# ATC1 | Use of Pier Wall for Bridges 405/103E and 405/103

RE: ATC 01 Rev 2: Use of Pier Wall for Bridges 405/103E and 405/103W  
I-405, Brickyard to SR 527 Improvement  
Design-Build Project

The Washington State Department of Transportation (WSDOT) has reviewed ATC 01, Use of Pier Wall for Bridges 405/103E and 405/103W Rev 2, as submitted on March 31, 2023. WSDOT's determination regarding this ATC is as follows:

The ATC is approved.

10 Figure 1, ATC-01 Conceptual design for Intermediate Pier 3 for Bridge 405/103E, similar to BR04 (now showing  
11 existing Culvert penetrating through the Pier Wall).

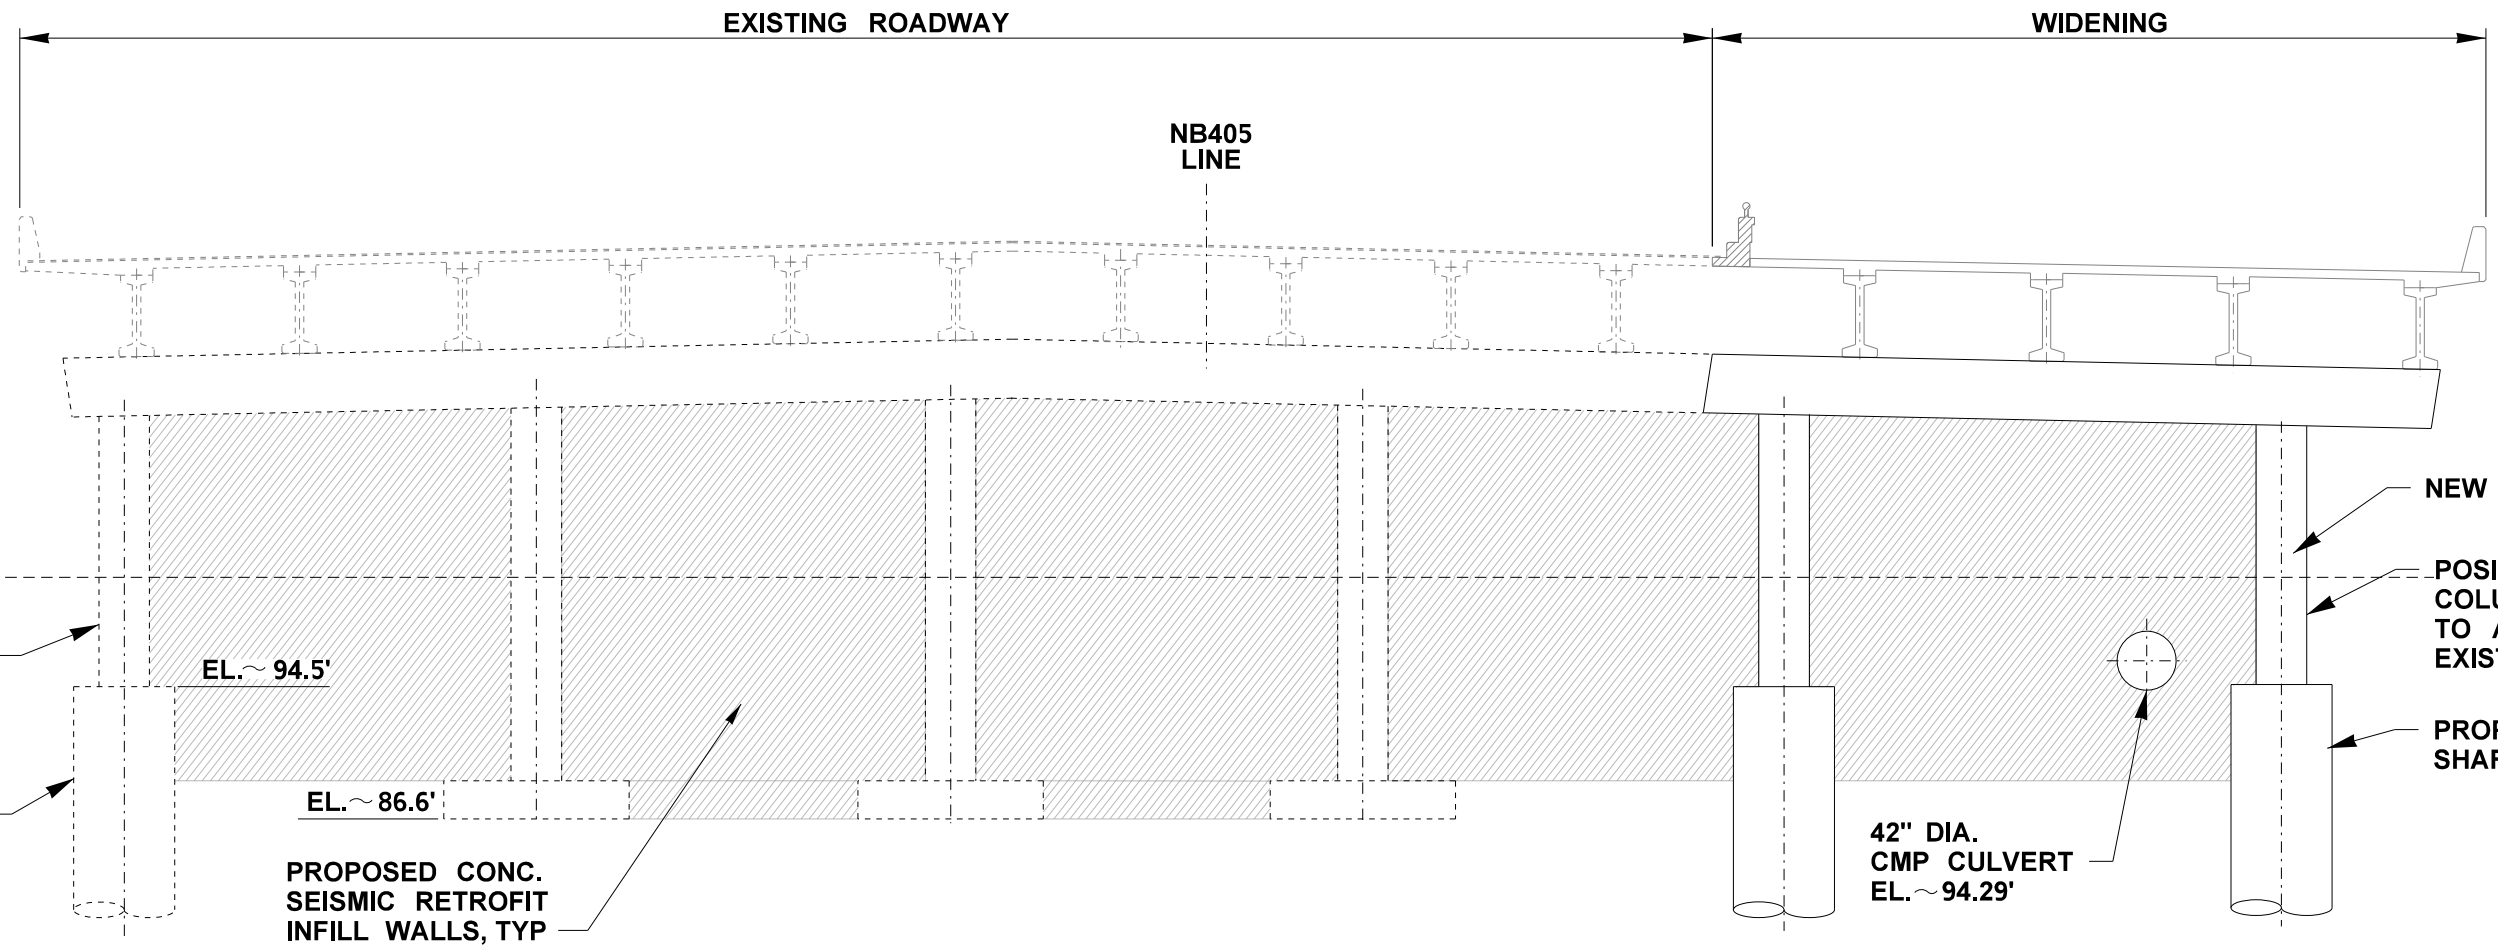
10 The conceptual plan configuration for Bridge 405/103E (Appendix M1, drawing BR-08) proposes  
11 using Infill Walls for retrofitting the columns and building two new columns under the widening.  
12 Figure 1 presents an extended elevation of the Infill Walls (from BR-08), including the existing South  
13 Fork Perry Culvert. It can be observed that the existing culvert is penetrating through the Infill Wall.

12 Figure 2, ATC-01 Proposed design for Intermediate Pier 3 for Bridge 405/103E where new columns are  
13 eliminated.

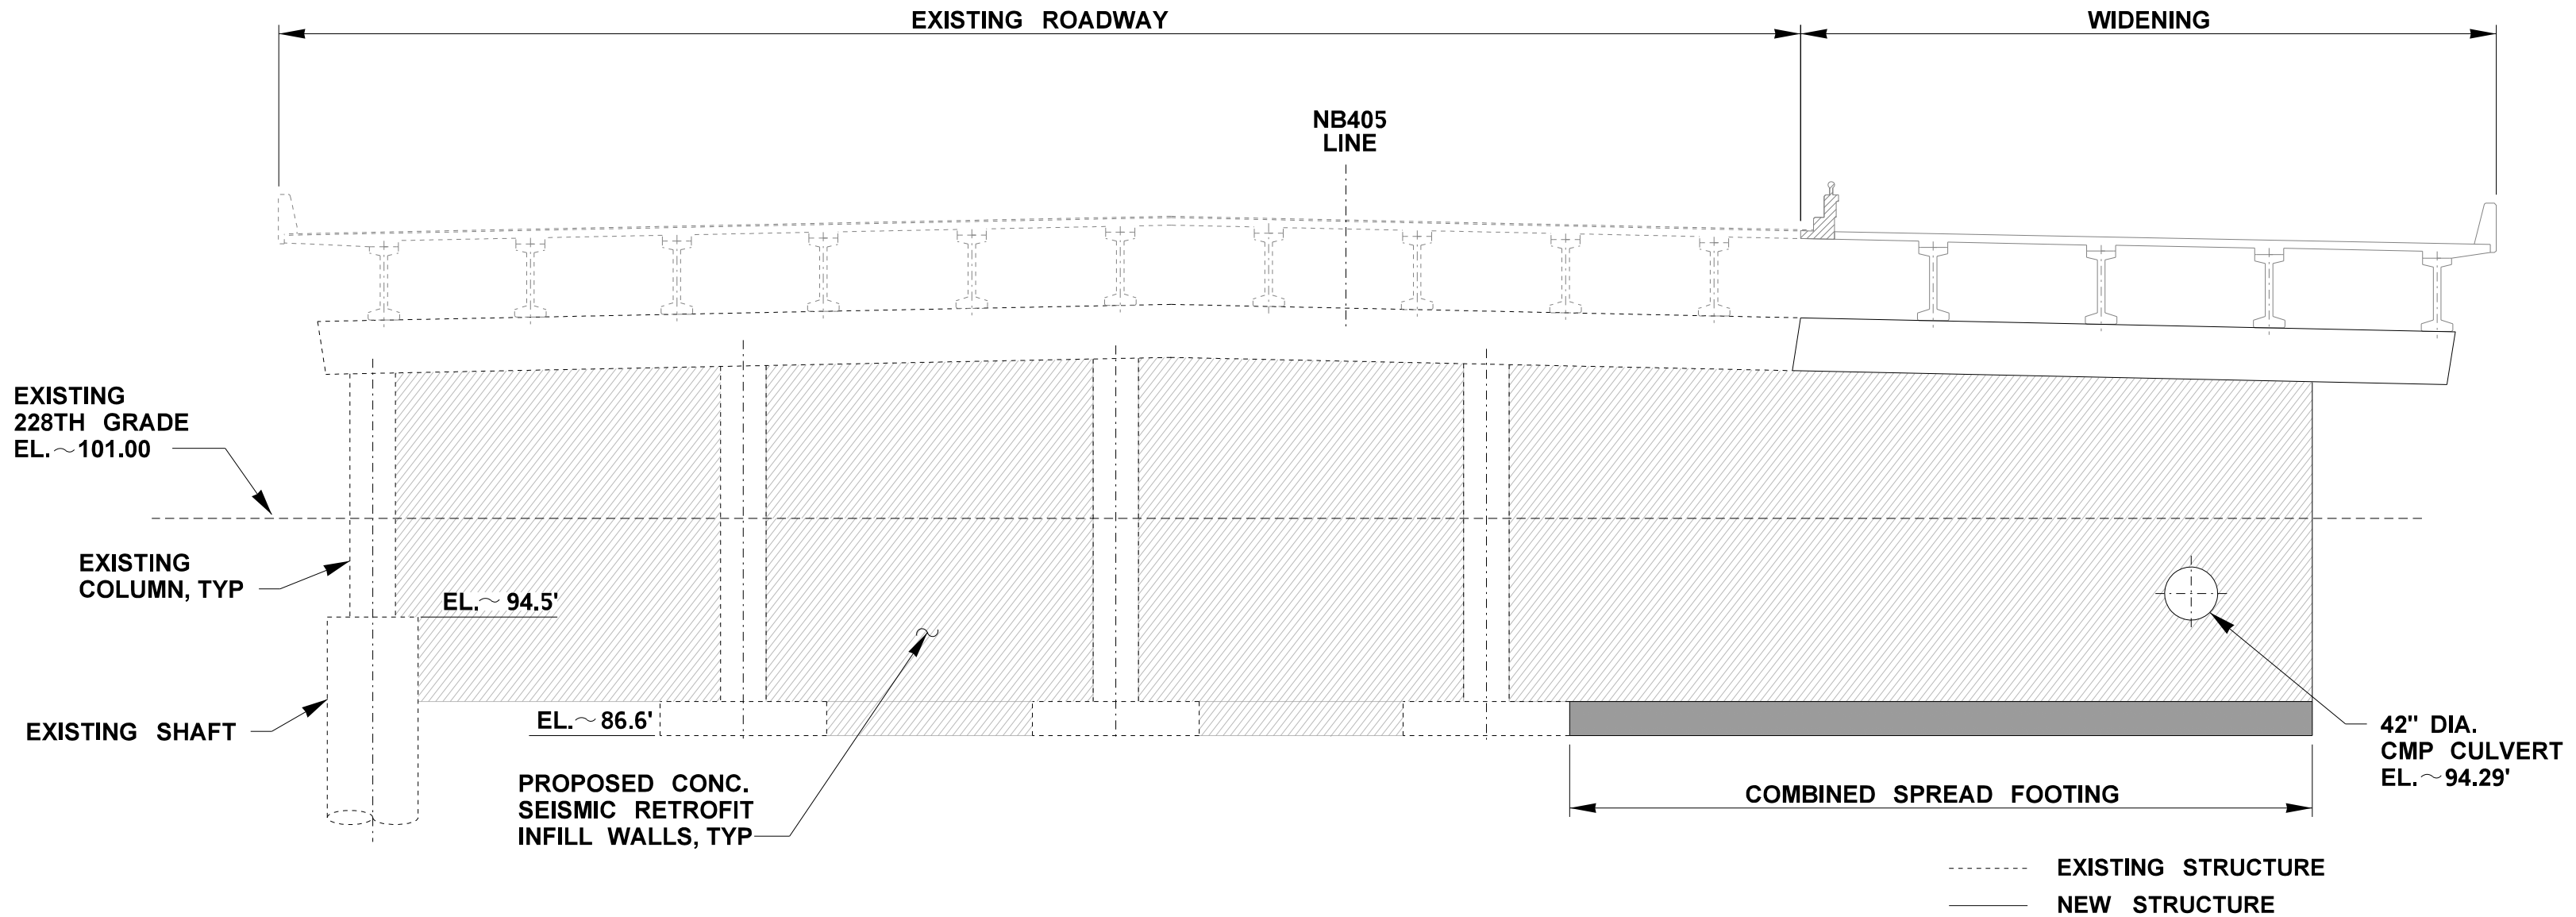
6 The Design Builder will protect in place the existing culvert during construction. The design and  
7 detailing of the Pier Wall at Bridge 405/103E, Pier 3 will consider the presence of the existing culvert  
8 by providing an oversized penetration through the Pier Wall for the pipe culvert.

- 23 4) A Pier Wall will be provided for Piers 2 and 3 as shown in Figure 2 (attached).
- 24 5) Girder seat extension and girder stops at abutments are needed.

- 28 1) Bridge 405/103E:
  - 29 a. New columns and drilled shaft under the widening will be eliminated from the  
30 design.
  - 31 b. Bolsters will not be provided for the Pier Cap for Piers 2 and 3 due to the  
32 presence of the Pier Wall acting as a deep beam in between columns.
- 33 2) Bridge 405/103W:
